Site / Mass Grading / Sediment Control Plans

Troy Hill Corporate Center

SDP-98-143

TROY HILL CORPORATE CENTER
 PHASE IIA
 TROY HILL DRIVE
 REVISED STORMWATER MANAGEMENT POND # 3

SCALE: AS SHOWN
 SHEET NO. 12 OF 13

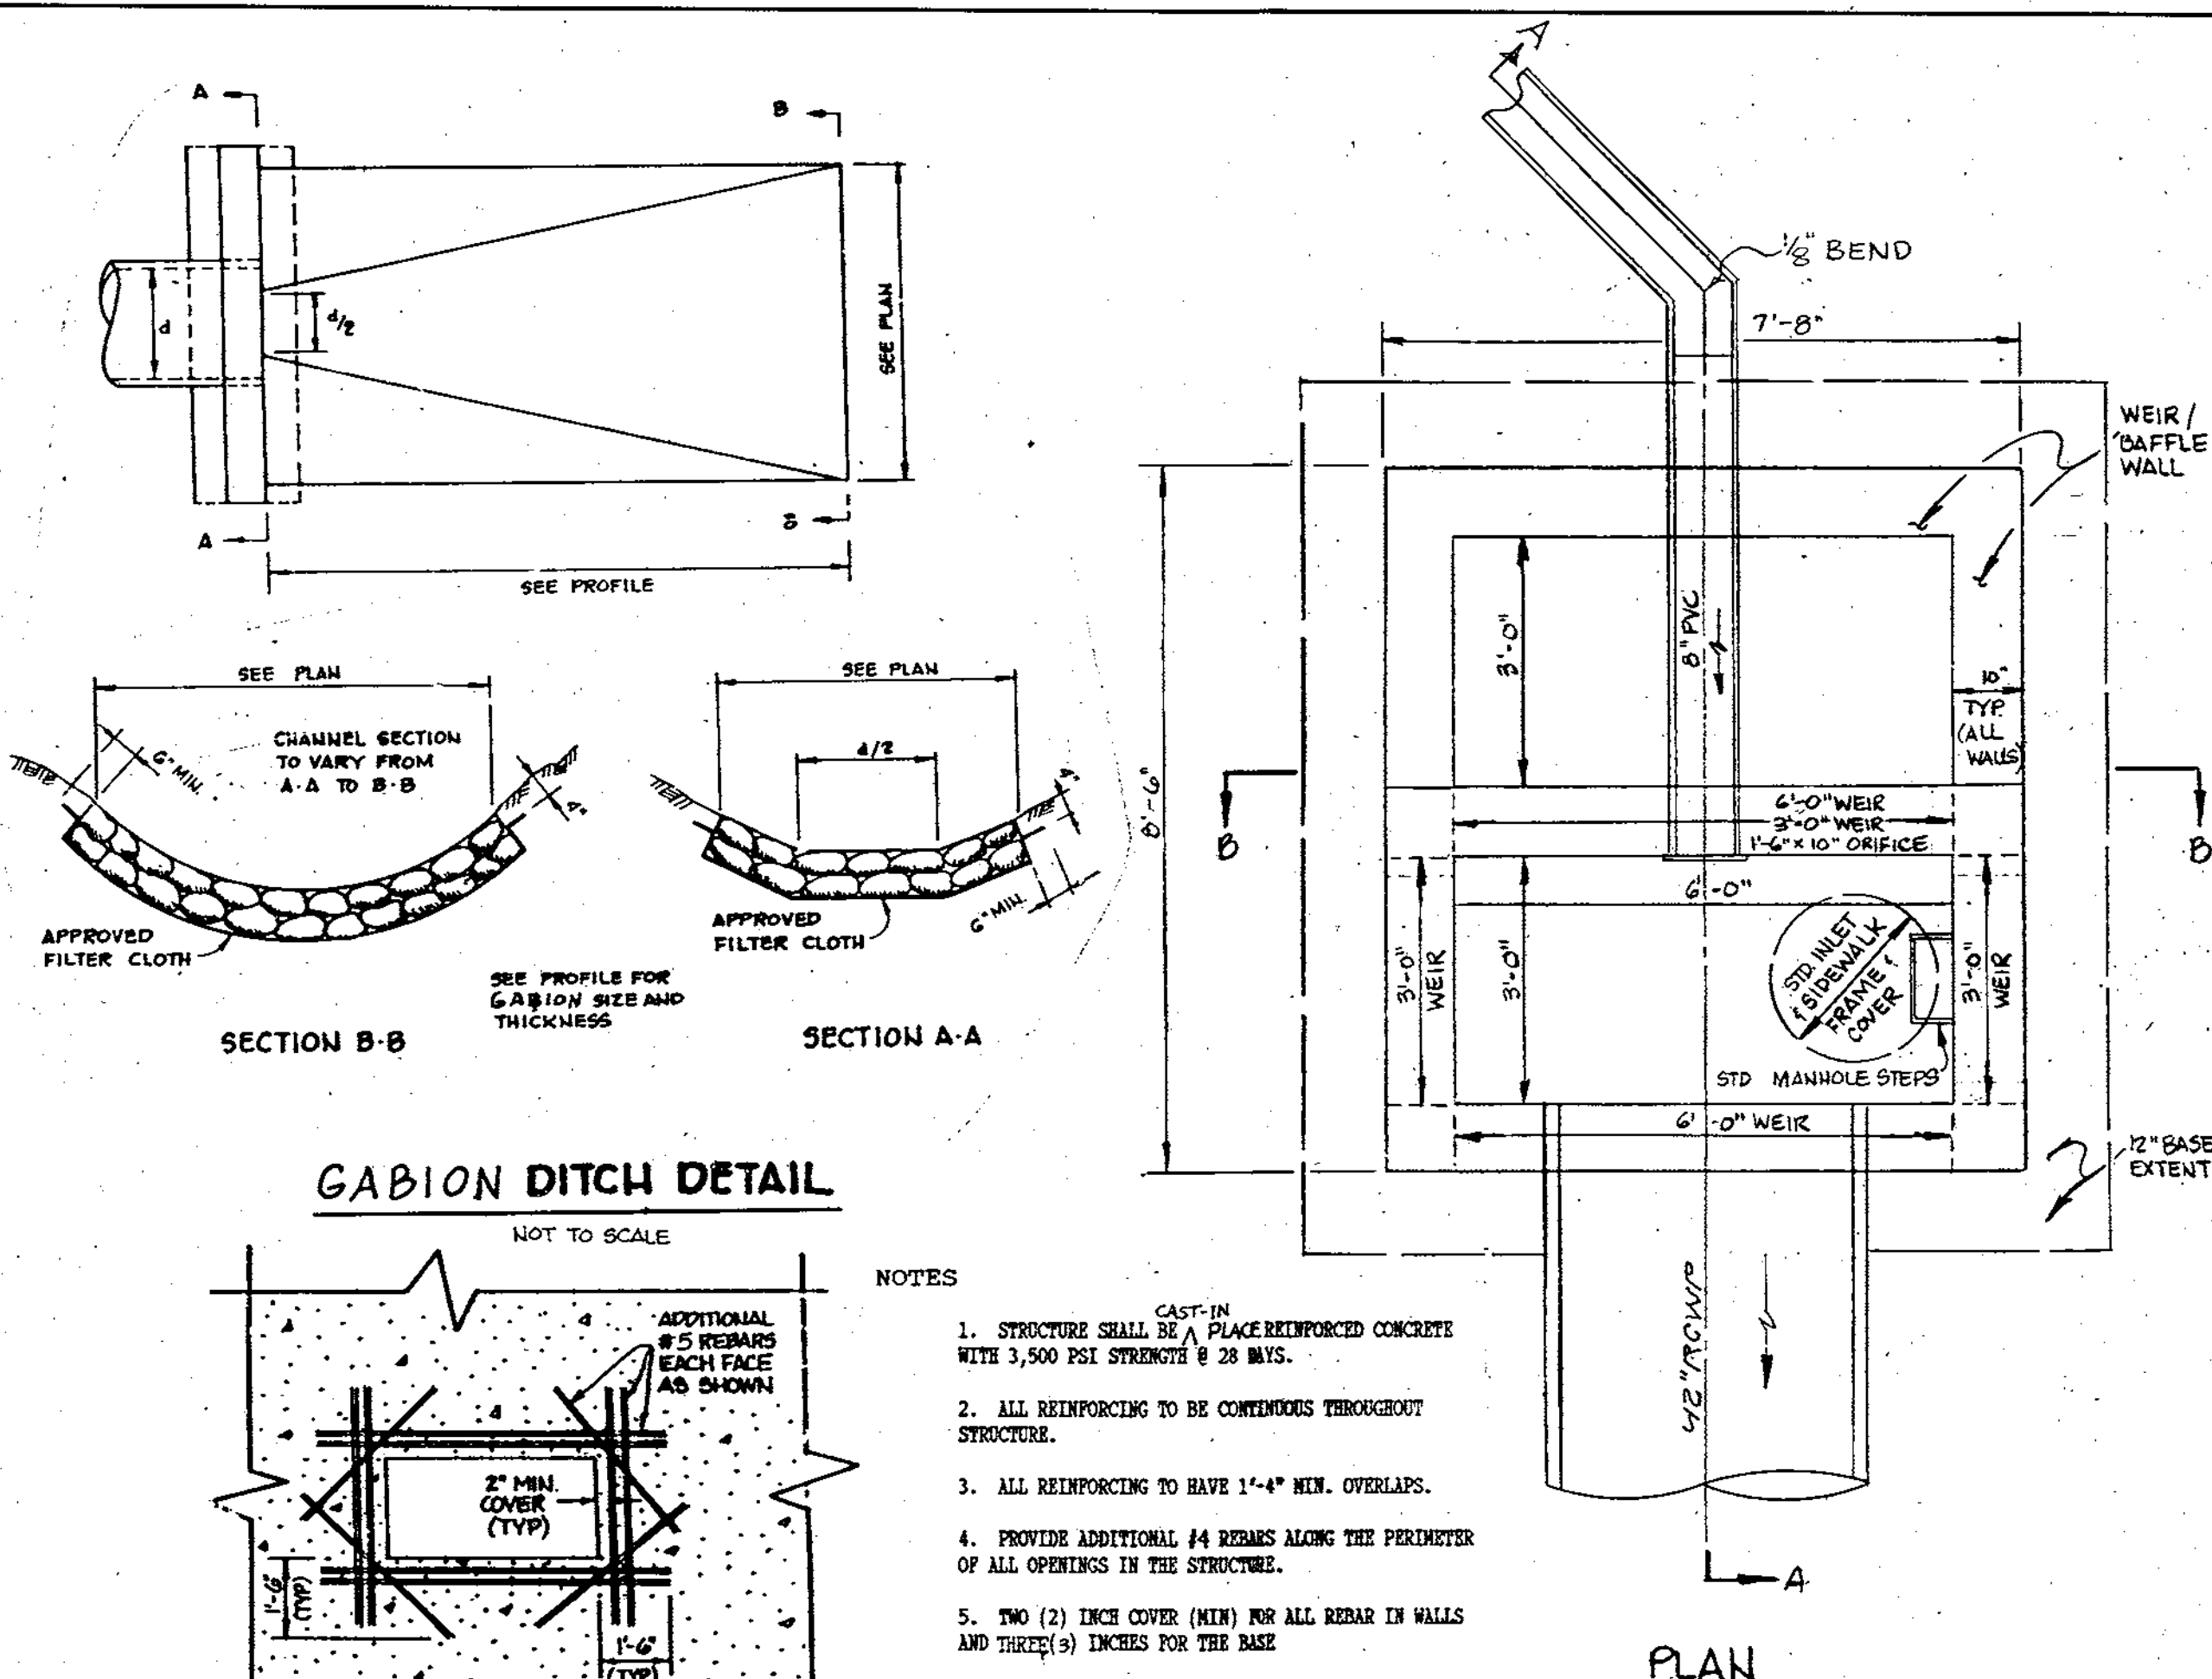
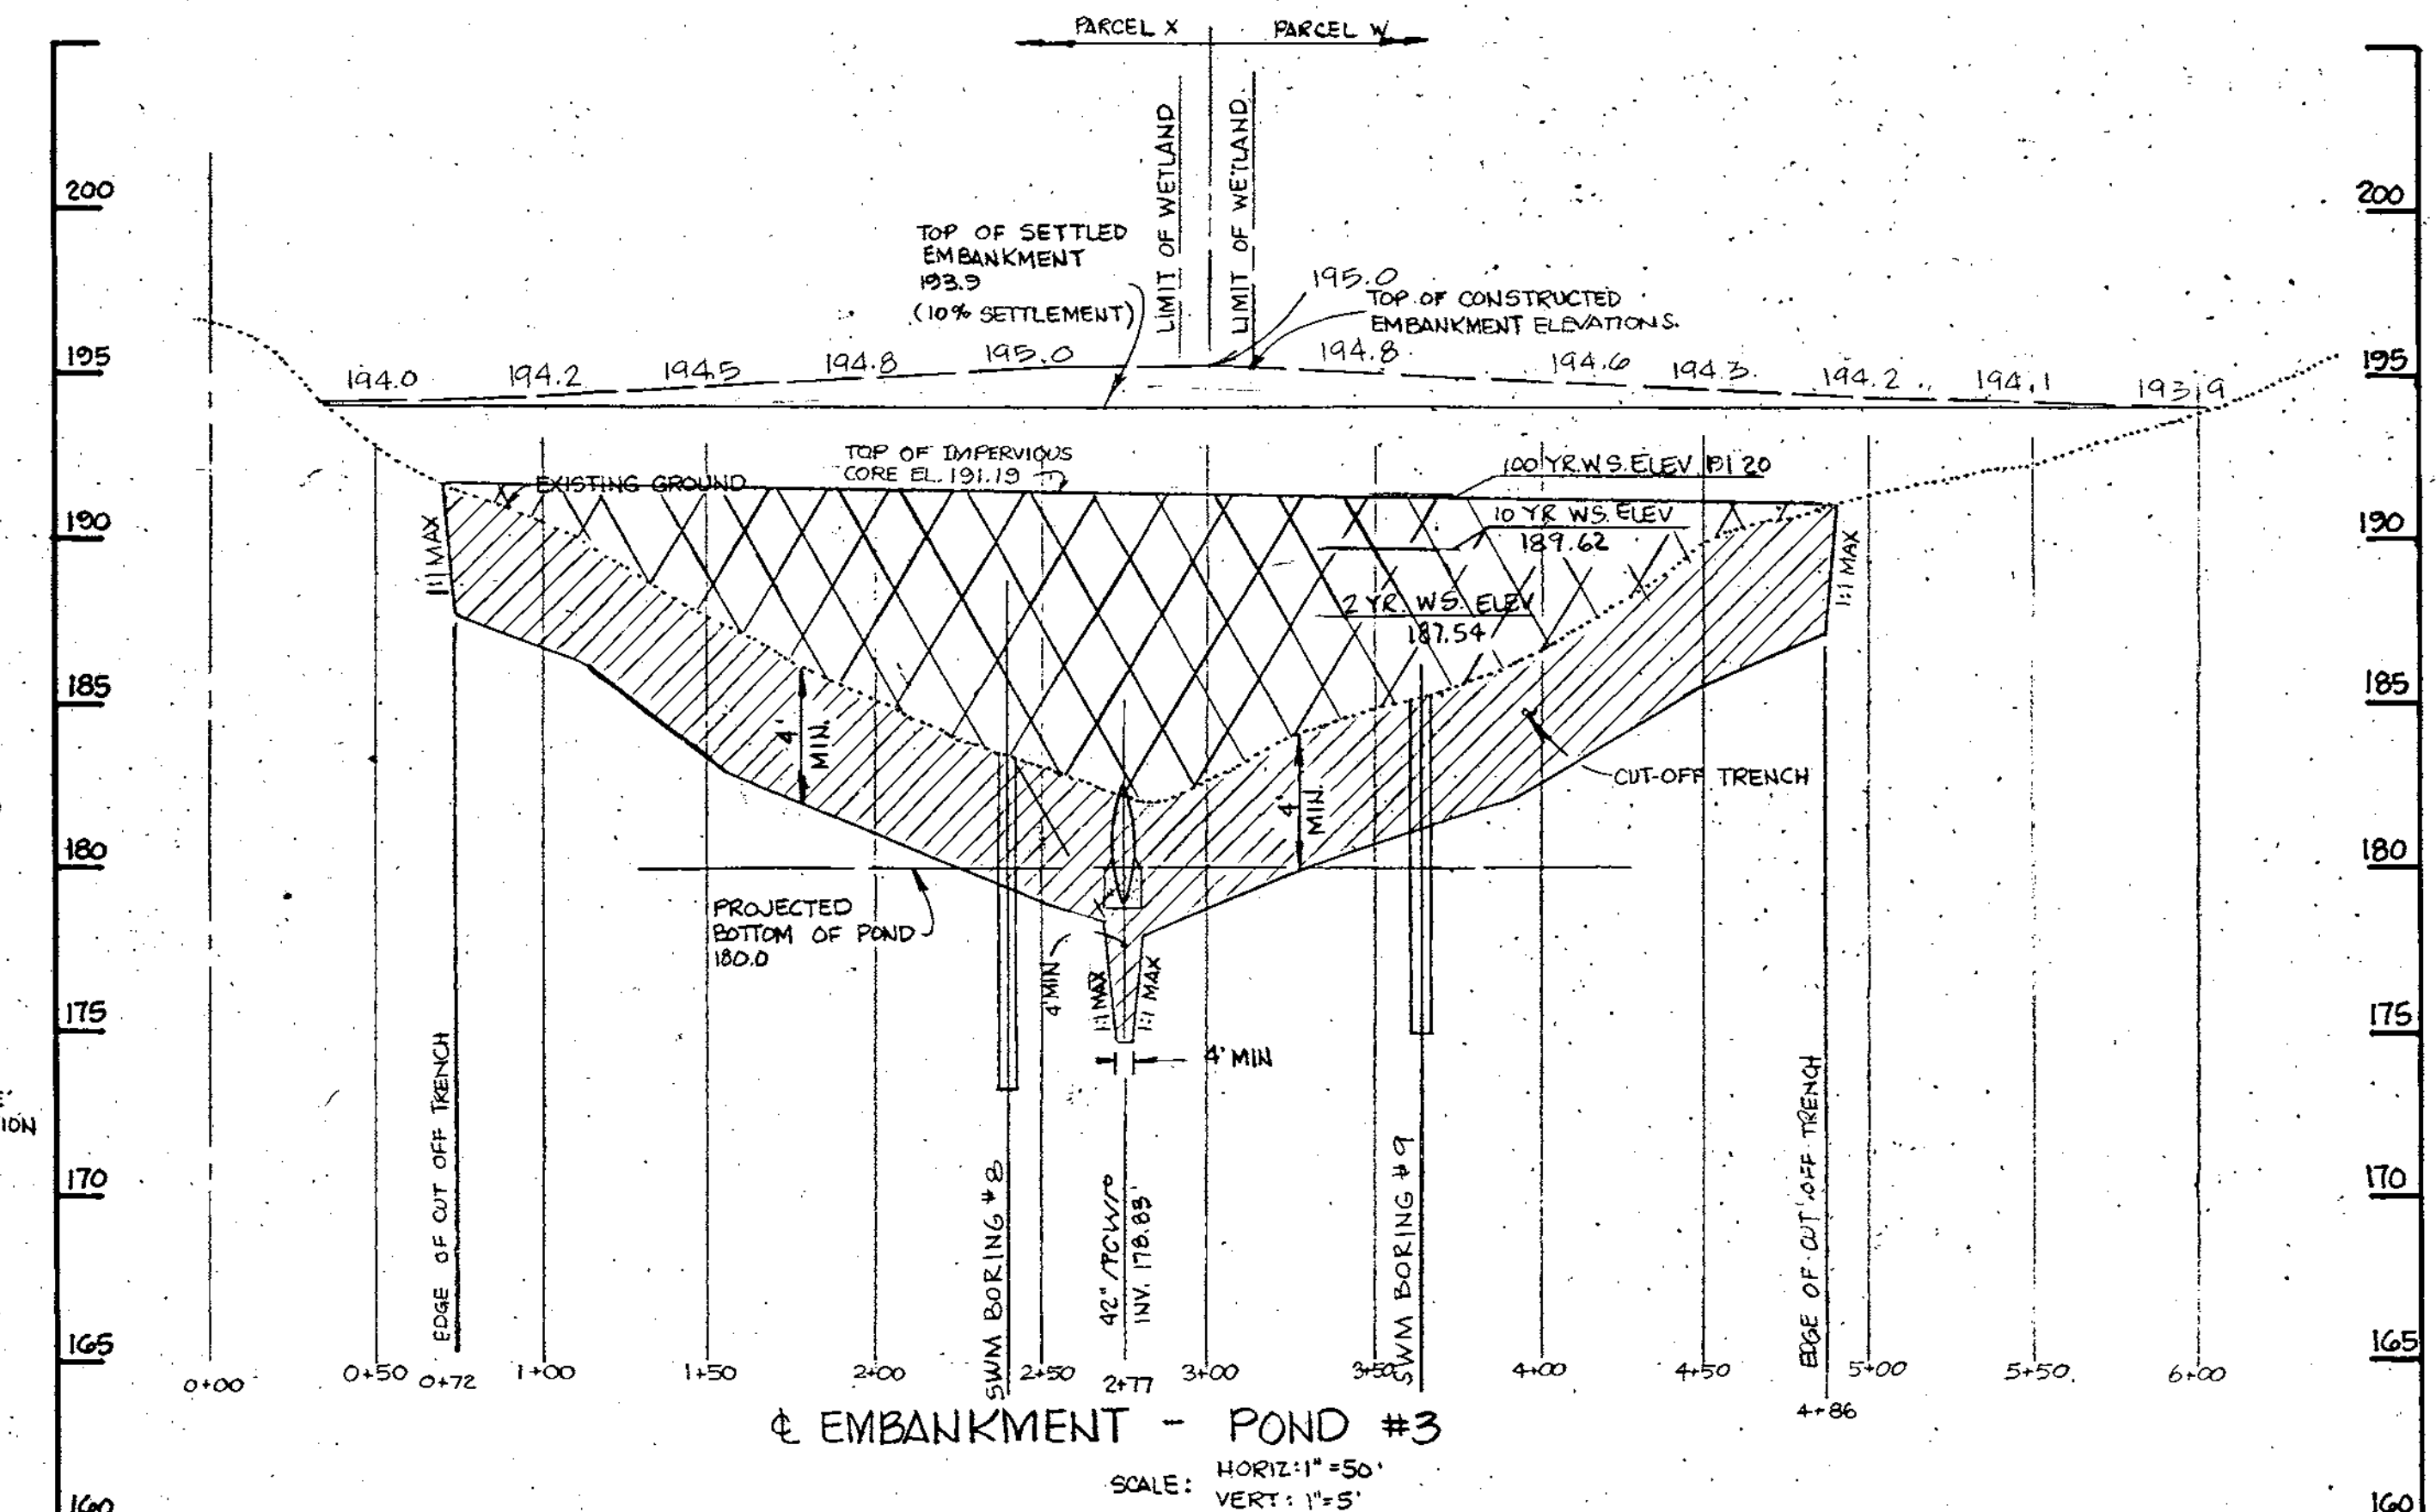
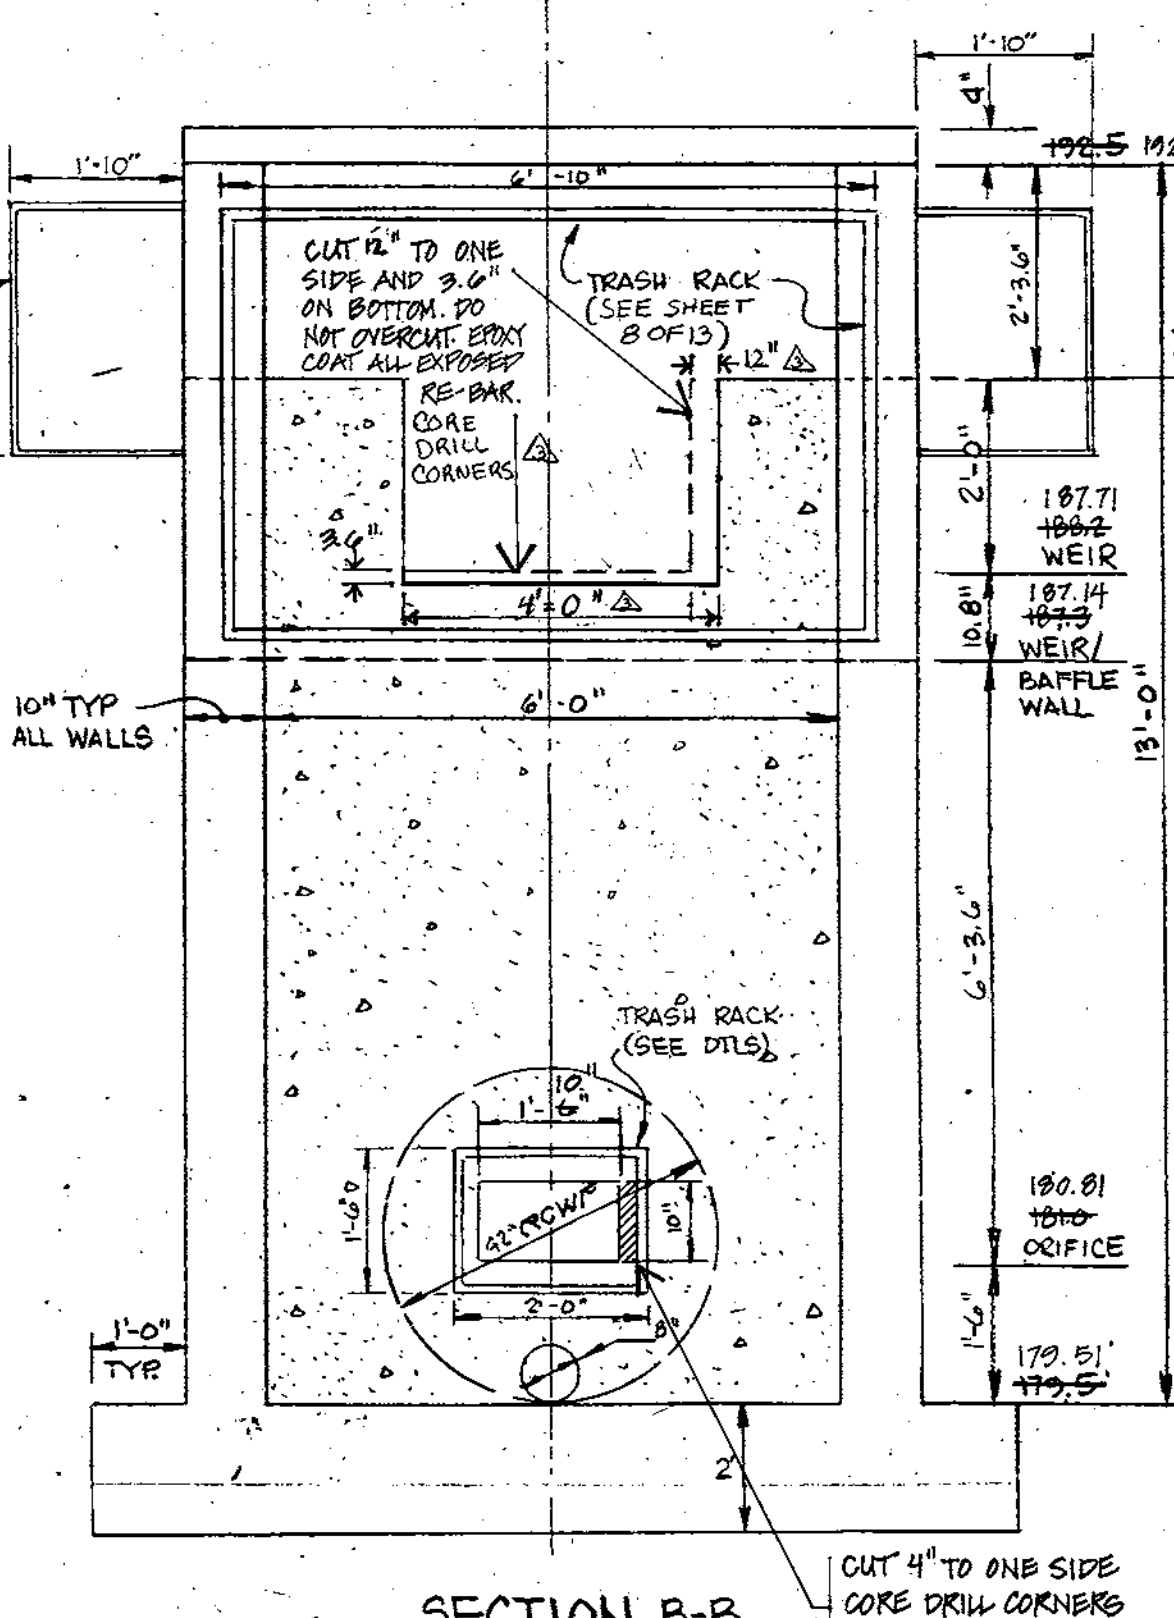
NO	REVISION	DATE
1	REVISE ACCESS RAMP GRAPES, MODIFY RISER, ELIMINATE LOW FLOW CHANNEL	11/09/98
2	Revise Riser Opening	11/20/98
